Southern Nuclear Operating Company  
Vogtle Electric Generating Plant Units 3 and 4  
Request for License Amendment:  
PMS Logic Changes for Source Range Flux Doubling (LAR-16-006)

**ND-16-0652**

**PMS Logic Changes for Source Range Flux Doubling**

**(LAR-16-006)**

**Tier 2 UFSAR Figure 7.2-1 (Sheet 3 of 21) Functional Diagram Nuclear Startup Protection, Figure update**

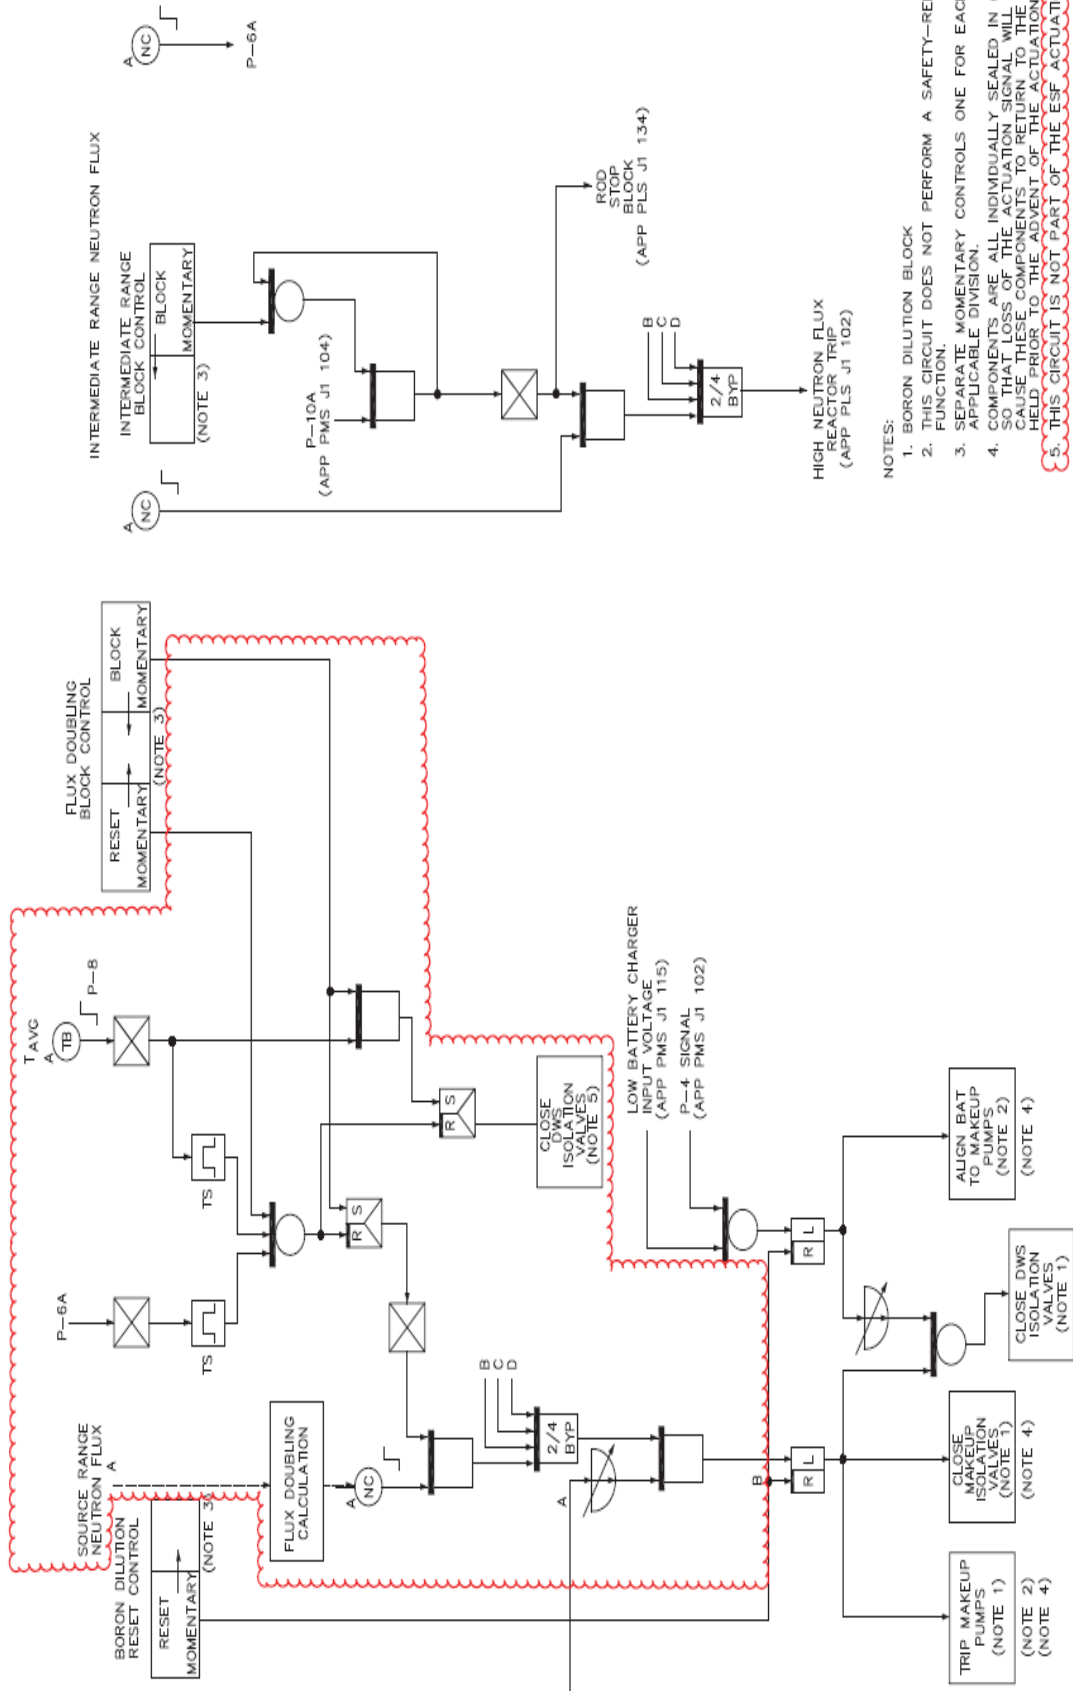
- Figure 7.2-1 (Sheet 3)

The PMS logic figure is changed to reflect the design changes described above, as follows:

- A close signal is sent to the CVS DWS isolation valves if the P-8 permissive is not set (i.e.,  $RCS T_{avg}$  is below the P-8 setpoint) and the operator blocks the flux doubling portion of the boron dilution block function.

- A circuit is added to automatically reinstate the flux doubling protection when plant conditions decrease to less than the P-8 setpoint. The circuit remains unchanged in the fact that it reinstates the flux doubling protection when plant conditions decrease to less than the P-6 setpoint.

- Since the new function block to "Close DWS Isolation Valves" is not required to mitigate any design basis event, a note is added to state that it is not an Engineered Safety Feature (ESF) actuation function. The existing function block to "Close DWS Isolation Valves" remains an ESF actuation function because it is required to mitigate a possible design basis event (i.e., boron dilution). Both functional blocks actuate closure of CVS valves 136A (PMS Division A) and 136B (PMS Division C). The physical components and process to close the CVS DWS isolation valves downstream of PMS are the same for each function block.
